1990 DEALER SERVICE MANUAL UPDATE BULLETIN SUPPLEMENT

**FOR THE 1990 CHEVROLET
LIGHT DUTY TRUCK UNIT REPAIR,
ASTRO VAN, C-K PICKUP TRUCKS, R-V-G-P MODELS,
AND S-10 MODELS SERVICE MANUALS**

ST-502-90SB

SERVICE MANUAL SUPPLEMENT

Figure 2 4WAL EHC Service Bleed Valves

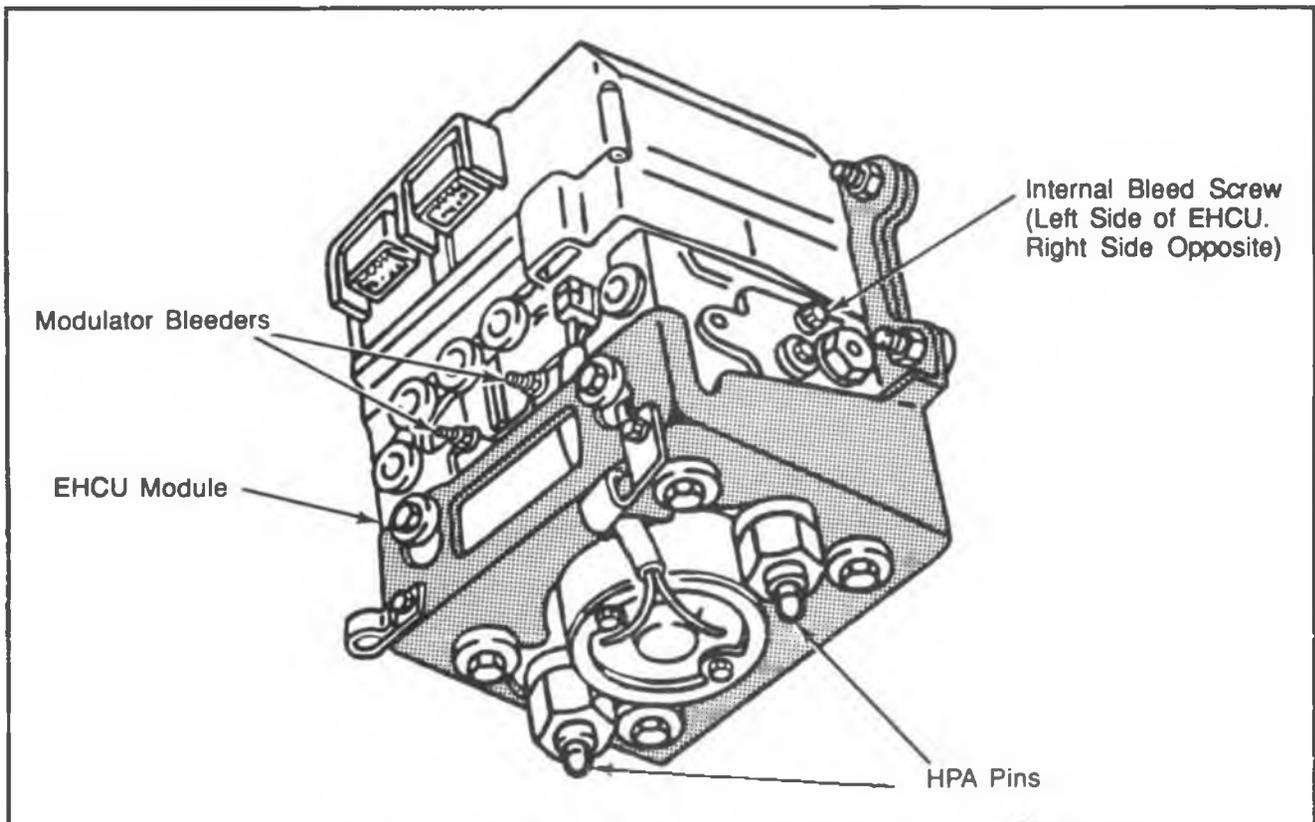
1. Assure ignition is in off position.
2. Deplete brake booster by pumping the brake pedal several times.
3. Assure the master cylinder is full.
4. Install two J 35856 bleed valve tools on the 4WAL EHCU at the high pressure accumulators (HPA) (see Figure 2).
5. Install one J 35856 bleed valve tool on the combination valve.
6. There are internal bleed screws on each side of the EHCU module (Figure 2). The bleed screws are used to open the internal passages within the EHCU module. Back off the two internal bleed screws 1/4 to 1/2 turn.
7. Use conventional bleeding process; Pressure, Vacuum or Pedal Bleeding.

There are two bleeders on the front of the unit that look like normal brake bleeders (Figure 2). These are the modulator bleeders for bleeding the EHCU module and they must remain closed when the unit is not pressurized.

8. EHCU Module Bleed Procedure (if required). Pedal bleeding method described below:

- Slowly depress the brake pedal one time and hold.
- Open one of the modulator bleeders on the front of the unit until fluid flows clearly or pedal is depressed.
- Close the modulator bleeder and tighten to 7 Nm. (60 in.lbs). **DO NOT OVER TIGHTEN!**
- Slowly release the pedal.
- Wait 15 seconds, then repeat the above sequence, including the 15 second wait until all air is purged from the EHCU module.

Repeat the above process on the remaining modulator bleeder on the front of the EHCU module until all air is purged from the unit.

Figure 1

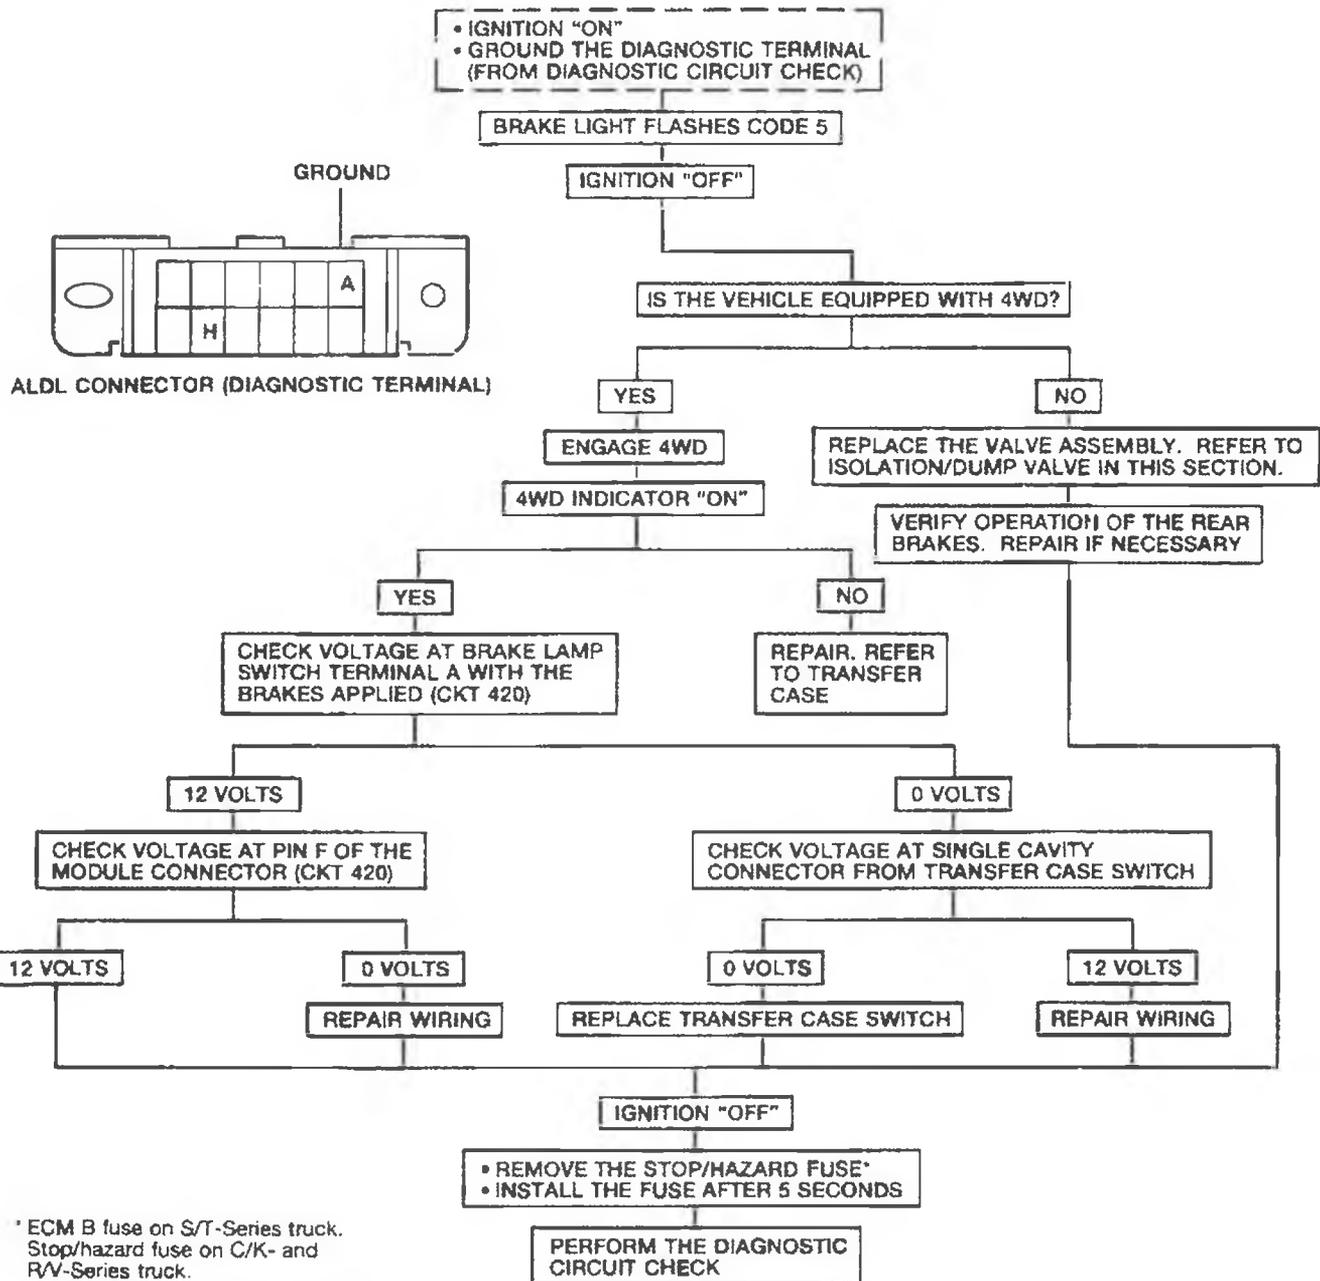
The attached chart (see Figure 1) is a revised code 5 diagnostic chart. The revised chart requires a check of wiring and the transfer case switch operation before the control valve is replaced on 4-wheel drive vehicles. The chart also revises code 5 diagnostic information in the following service manuals:

CODE 5 EXCESSIVE ACTUATIONS OF THE DUMP VALVE DURING AN ANTILOCK STOP

* ECM B fuse on S/T-Series truck.
Stop/hazard fuse on C/K- and RV-Series truck.
Horn/dome fuse on M-Series truck.
Tail LPS fuse on G-Series truck.

CHART C-1D

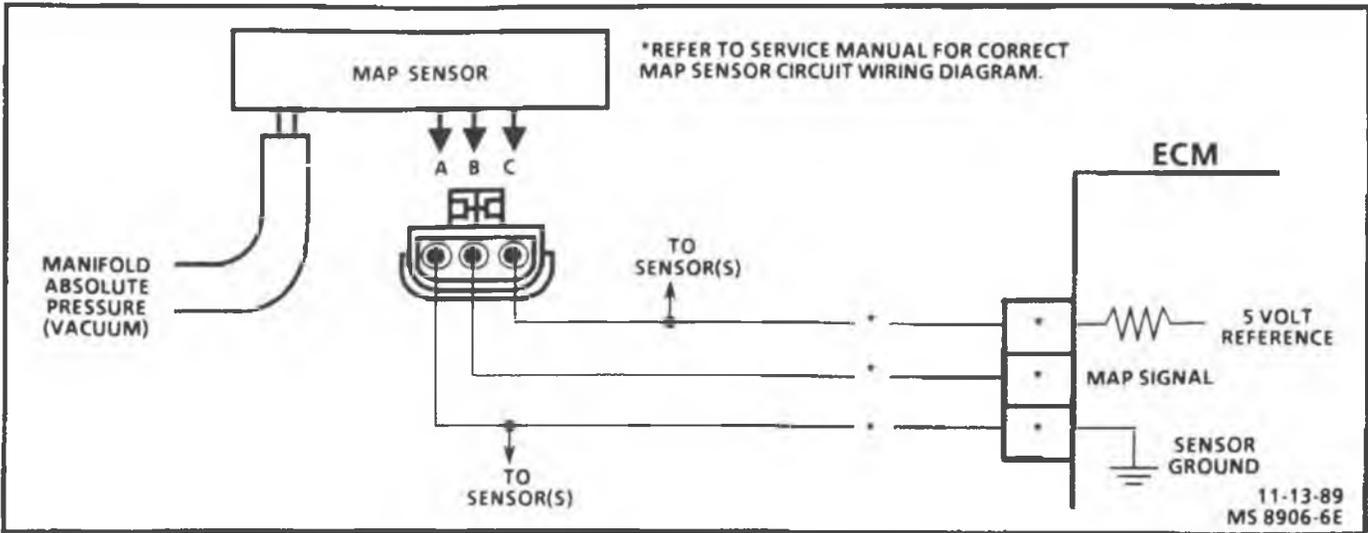
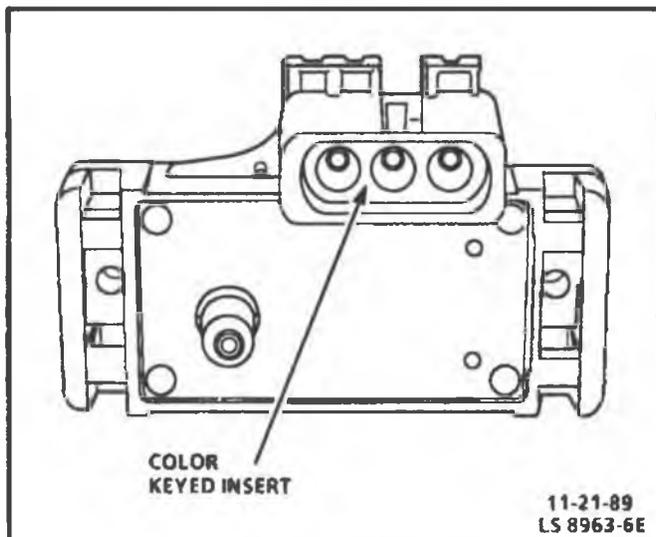
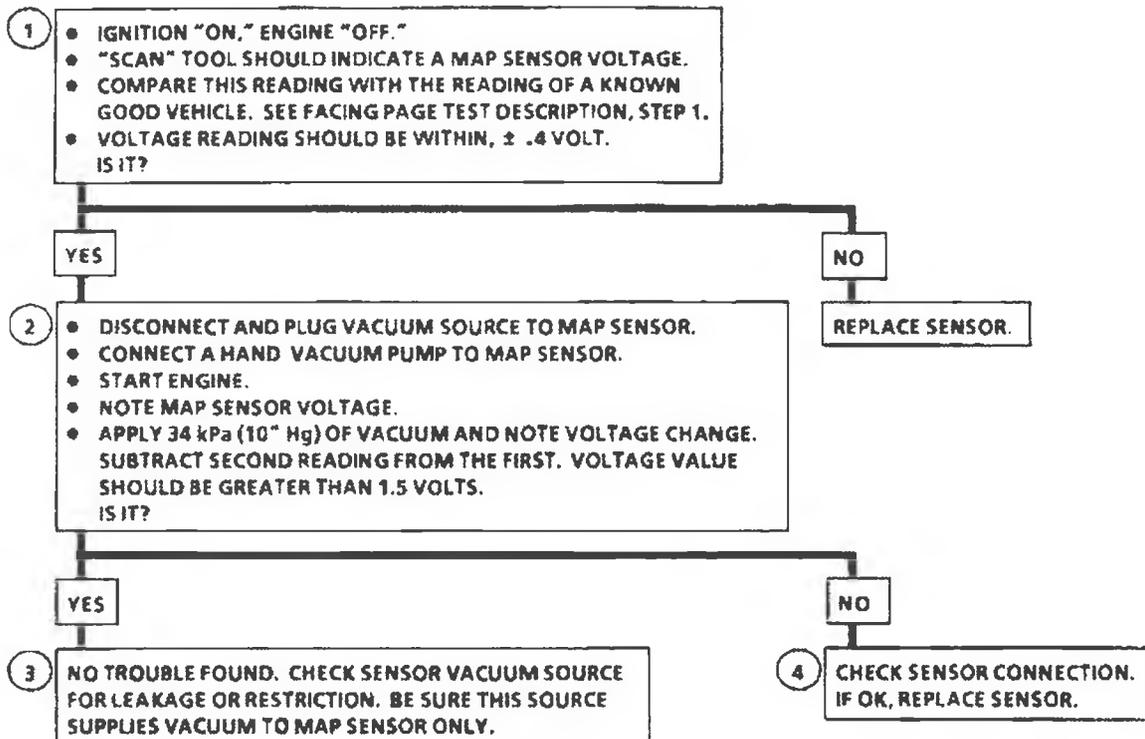
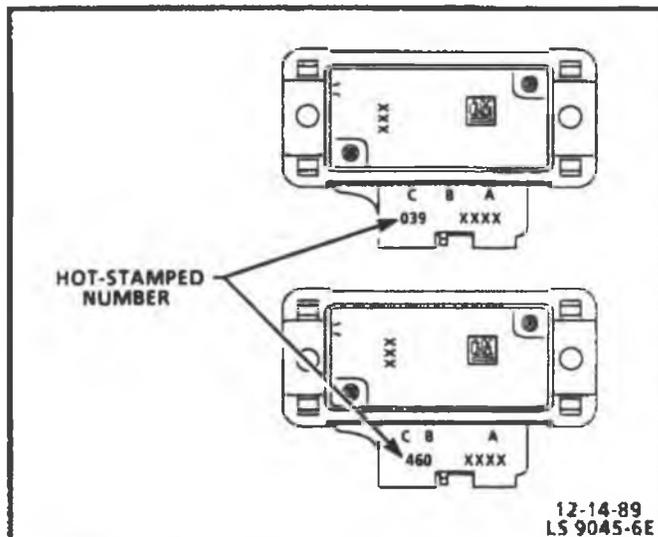
This bulletin revises the Manifold Absolute Pressure (MAP) Output Check Chart C-1D and updates Code 33, Code 34, Code 63, and Code 64 in the Service Manual section on "Driveability And Emissions" (Section 6E1, 6E2, and 6E3). This information applies to all MAP Sensors on 1980-1990 vehicles with gasoline engines (except turbocharged) with green (standard) MAP sensor electrical connector insert or the solid black MAP sensor electrical connector insert.

- Diagnostic Chart C-1D and facing page.

- Be sure to use the same Diagnostic Test Equipment for all measurements.
- 1. When comparing "Scan" readings to a known good vehicle, it is important to compare vehicles that use a MAP sensor having the same color insert or having the same "Hot Stamped" number. See figures on facing page.
- 2. Applying 34 kPa (10" Hg) vacuum to the MAP sensor should cause the voltage to change. Subtract second reading from the first. Voltage value should be greater than 1.5 volts. Upon applying vacuum to the sensor, the change in voltage should be instantaneous. A slow voltage change indicates a faulty sensor.

3. Check vacuum hose to sensor for leaking or restriction. Be sure that no other vacuum devices are connected to the MAP hose.

4. Disconnect sensor from bracket and twist sensor by hand (only) to check for intermittent connection. Output changes greater than .1 volt indicate a bad connector or connection. If OK, replace sensor.

CODE 33

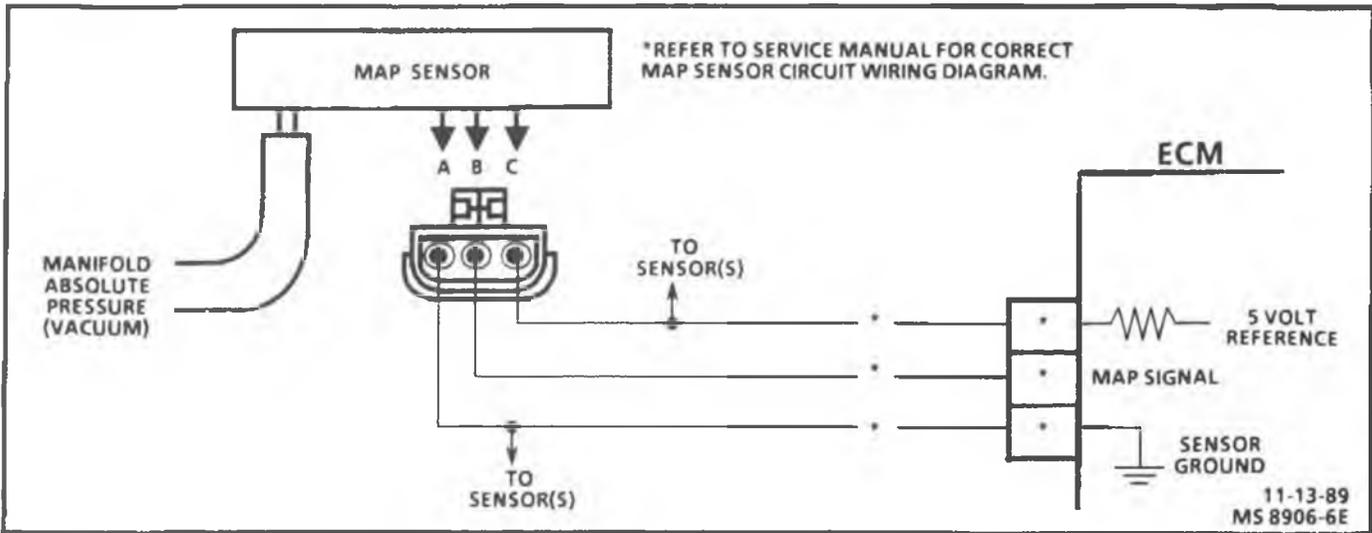
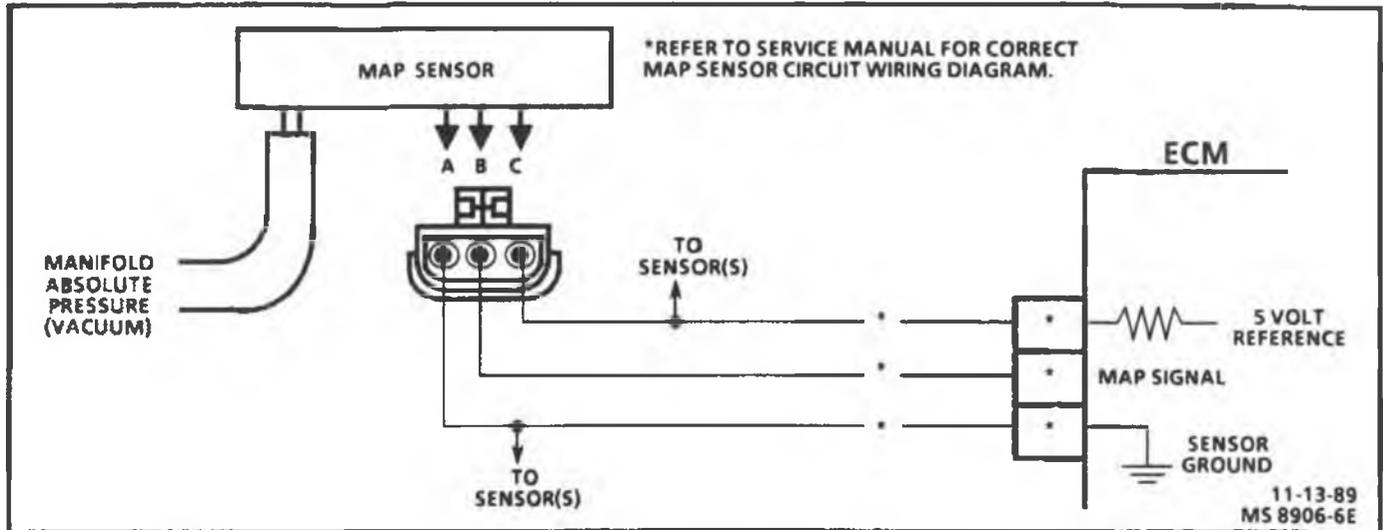
- Diagnostic Chart Code 33 and facing page.
- Diagnostic Chart Code 34 and facing page.
- Diagnostic Chart Code 63 and facing page.
- Diagnostic Chart Code 64 and facing page.

1. This step will determine if Code 33 is the result of a hard failure or an intermittent condition.
A Code 33 will set under the following conditions:
 - MAP signal voltage is too high (low vacuum).
 - TPS less than 2%.
 - These conditions exist longer than 5 seconds.
2. This step simulates conditions for a Code 34. If the ECM recognizes the change, the ECM and CKT 416 and CKT 432 are OK. If CKT 469 is open, there may also be a stored Code 23.

A Code 33 will result if CKT 469 is open or if CKT 432 is shorted to voltage or to CKT 416.

- Check all connections.
- Disconnect sensor from bracket and twist sensor by hand (only) to check for intermittent connections. Output changes greater than .1 volt indicates a bad connector or connection. If OK, replace sensor.
- Refer to CHART C-1D, MAP sensor voltage output check for further diagnosis.

PRELIMINARY CHECK PROCEDURE

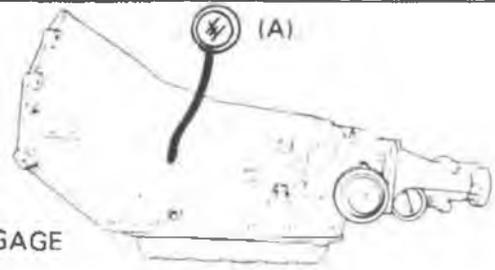
This bulletin provides a revised Preliminary Check Procedure and Shift Speed Chart for 1990 HM4L60/700-R4 transmissions. These charts have been updated since publication of the 1990 Service Manuals. Please make reference to these changes in your service manuals.

- CHECK TRANSMISSION FLUID LEVEL
- CHECK AND ADJUST T.V. CABLE
- CHECK OUTSIDE MANUAL LINKAGE AND CORRECT
- CHECK ENGINE TUNE
- INSTALL PRESSURE GAGE
- CONNECT TACHOMETER TO ENGINE
- CHECK PRESSURE AS FOLLOWS:

Set the T.V. cable to specification; and with the brakes applied, take the line pressure readings in the ranges and at the engine r.p.m. indicated in the chart below.

Full T.V. line pressure readings are obtained by tying or holding the T.V. cable to the full extent of its travel; and with the brakes applied, take the line pressure readings in the ranges and at the engine r.p.m. indicated in the chart below.
